## PLANNING CONSULTANCY

**Re : Planning and Development Act 2000-2022 and the statutory regulations (as amended). Application by Vantage Data Centers DUB11 Ltd. for development for the demolition of the two storey dwelling (207.35sqm) and associated outbuildings and farm structures (348.36sqm); and the construction of 1 no. two storey data center with plant at roof level and associated ancillary development that will have a gross floor area of 12,893sqm at this site of 3.79 hectares to the south of the New Nangor Road (R134); and on land within the townlands of Ballybane and Kilbride within Profile Park, Clondalkin, Dublin 22.**

**Reg. Ref. SD22A/0420**

### ADDITIONAL INFORMATION

*Photomontage of revised elevations of proposed development as submitted under this AI submission in year 5 after completion*

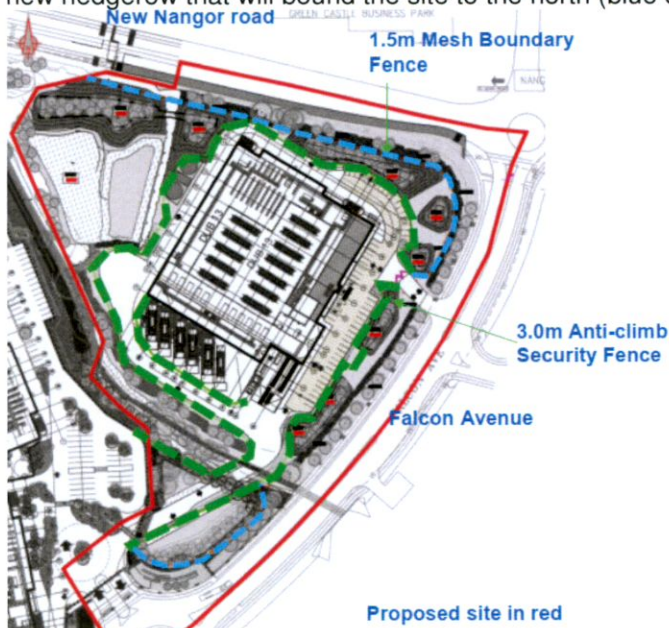
**2. (a) The applicant is requested to reconsider the elevational treatment and design along prominent frontages in terms of design and materials used.**

As outlined within the Design Statement (page 19) the elevational treatment and design from the most prominent public frontages has been reconsidered. This included reviewing the degree of greenery, canopy and levels of glazing. The design introduces an increased level of fenestration to the most prominent north-east elevation that wraps around this prominent corner. This provides a high quality entrance into Profile Park, as well as forming a strong elevation as viewed from the New Nangor Road.

As the montage above indicates, the changes made, with the substantive landscaping proposed in terms of new hedgerows, berms, planting and trees, will positively enclose the site to provide a positive visual entrance into Profile Park and this part of Grange Castle. In addition, and as per the request outlined in Point 2(b) an updated fence and boundary treatment plan is provided (see Drawing no. A107 prepared by Hyphen). There are two proposed fence types and this is detailed on page 20 of the Design Statement, as well as below. An internal 3m high anti-climb security fence will enclose the hardstanding area (see green line below) with an outer 1.5m high fence to be located around the attenuation pond to the south, and to the rear of the proposed new hedgerow that will bound the site to the north (blue dashed line below).

*Proposed fencing plan*

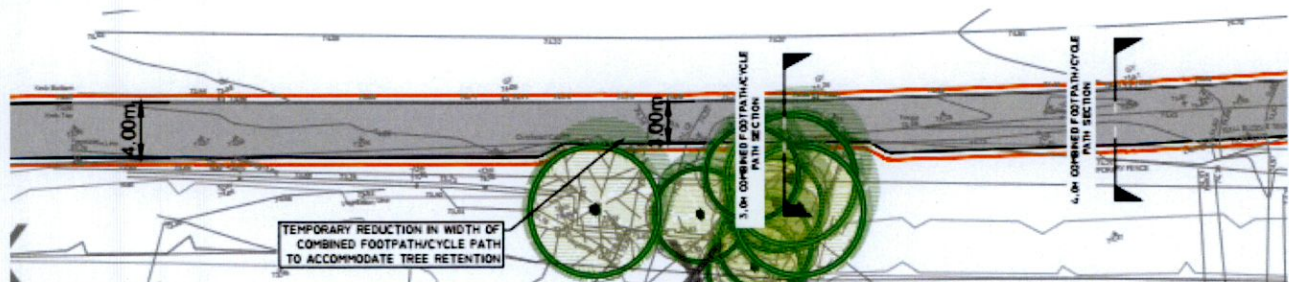
**(b) The applicant is requested to provide details of fencing / boundary treatment.**

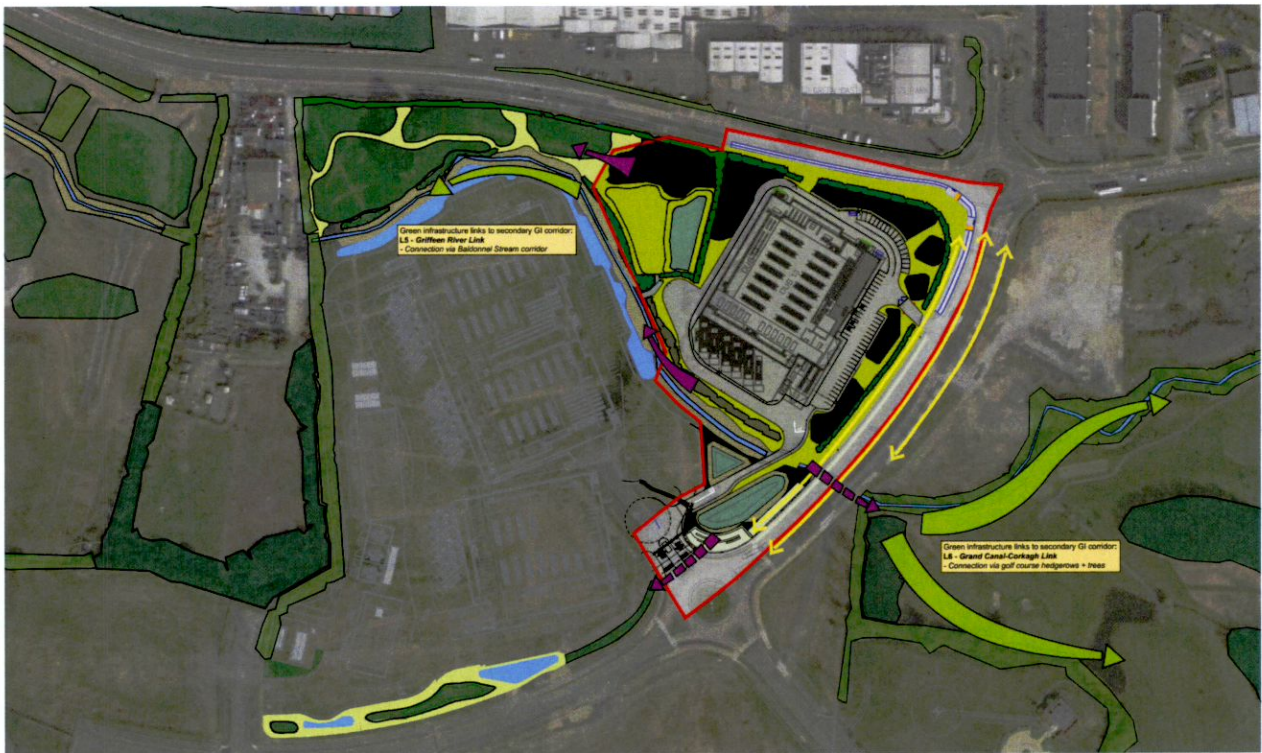
**5. The applicant is requested to submit a revised landscape strategy for the subject site which meets the requirement of the Public Realm Section in terms of Green Infrastructure as required under the CDP 2022-2028. The applicant shall demonstrate how they contribute to the protection or enhancement of Green Infrastructure in the County through the provision of green infrastructure elements as part of the application submission. As part of the revised landscape proposals the applicant shall provide the following additional information:**

- i. The applicant is requested to submit a fully detailed Planting Plan to accompany the landscape proposals for the entire development. The applicant should propose native species where possible to encourage biodiversity and support pollinators within the landscape.**

- ii. The revised proposals shall include hard and soft landscape details; including levels, sections and elevations, detailed design of SUDs features including swales and integrated/bio-retention tree pits.**

In accordance with this request, Kevin Fitzpatrick Landscape Architecture (KFLA) has submitted a fully detailed planting plan (See Drawing no. 203 from KFLA) that is based on the exclusive use of native species and planting that will encourage biodiversity and support pollinators within the landscape.

The landscape and drainage proposals submitted as part of this AI Response have indicated the extensive use of SUDs measures throughout. These include permeable paving, bio-retention tree pits, bioswales and others. The description and areas of these permeable and other surfaces are clearly set out on Drawing no. C130 submitted with this AI Response.

Excerpt from Drawing no. 201 submitted by Kevin Fitzpatrick Landscape Architecture as part of this response, indicating central hedgerow to be retained, and new hedgerow being proposed (outlined in yellow)

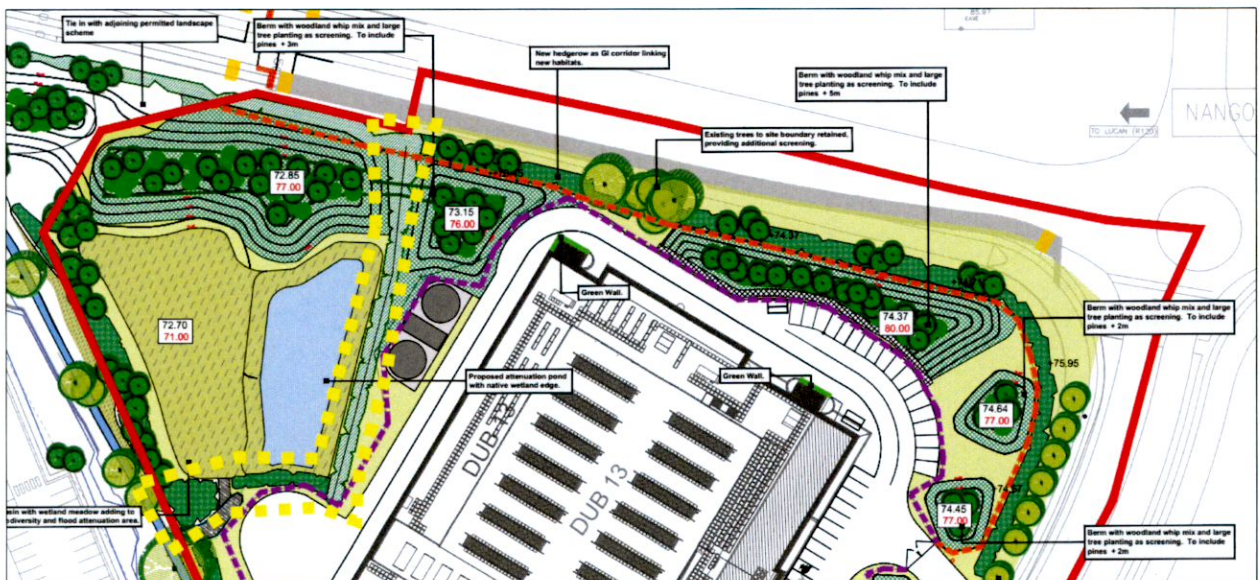
**7. The applicant is requested to submit a revised layout plan which ensures the retention and enhancement of the existing central hedgerow located in the northern portion of the site. The current proposals and design layout for the development which requires the removal of this important hedgerow and GI asset is not acceptable to the Public Realm Section and its removal contravenes the following policies and objectives which the CDP 2022-2028.**

We respectfully submit that Policies NCBH11, Objective 3; GI1, Objective 4; and GI2, Objective 2 have informed the overall approach to the proposed development. We refer the Planning Authority to our response to Point 6 of this AI Response in terms of the amendment of the scheme to retain 75m of the central hedgerow and the planting of a native hedgerow to ensure that the biodiversity and wildlife corridor between the north of the site and the Baldonnell Stream corridor is retained. This element results in the loss of 36m of native hedgerow, and its replacement with 30m of native hedgerow to link into the Baldonnell Stream corridor. This approach, and irrespective of the significant planting being proposed throughout the rest of the site, as detailed in the resubmitted Planting Plan (Drawing no. 203 by KFLA) will protect and enhance the existing trees, hedgerows and where they are not possible to be retained, as is the case for 36m of the central hedgerow, that the highest value biodiversity provision and planting of native species is proposed for the overall site, that will undoubtedly not only protect but improve the wildlife amenity of the site fully in accordance with Policy NCBH11, Objective 3 of the County Development Plan.

Fully in accordance with Policy GI1, Objective 4, the layout of the proposed development as originally applied for, and further enhanced under this AI response, has fully incorporated Green Infrastructure and environmental assets into the overall design. The Landscape Plan submitted as part of this AI Response (Drawing no. 201 submitted by KFLA) indicates all of the environmental assets being retained, and the new hedgerow and tree planting being proposed, with further details provided in the Planting Plan (Drawing no. 203 submitted by KFLA). This has been informed by ensuring that the design links into adjacent and wider GI networks as set out under the GI Plan that is indicated on Drawing no. 205 submitted by KFLA fully in accordance with Policy GI1, Objective 4 of the County Development Plan.

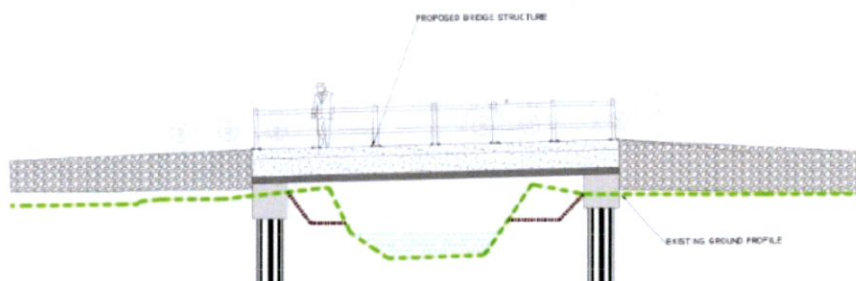
**14. (a) where possible, the applicant is requested to replace proposed overflow pipe with an open swale or natural open channel.**

As per the above, the previously piped outlet from Drainage Basin 1 into the stream has been replaced by a natural open channel / swale in accordance with point (a) of this part of the AI request. This is shown in Drawing no. C127. There are no further opportunities to replace piping with open swales or channels. Our
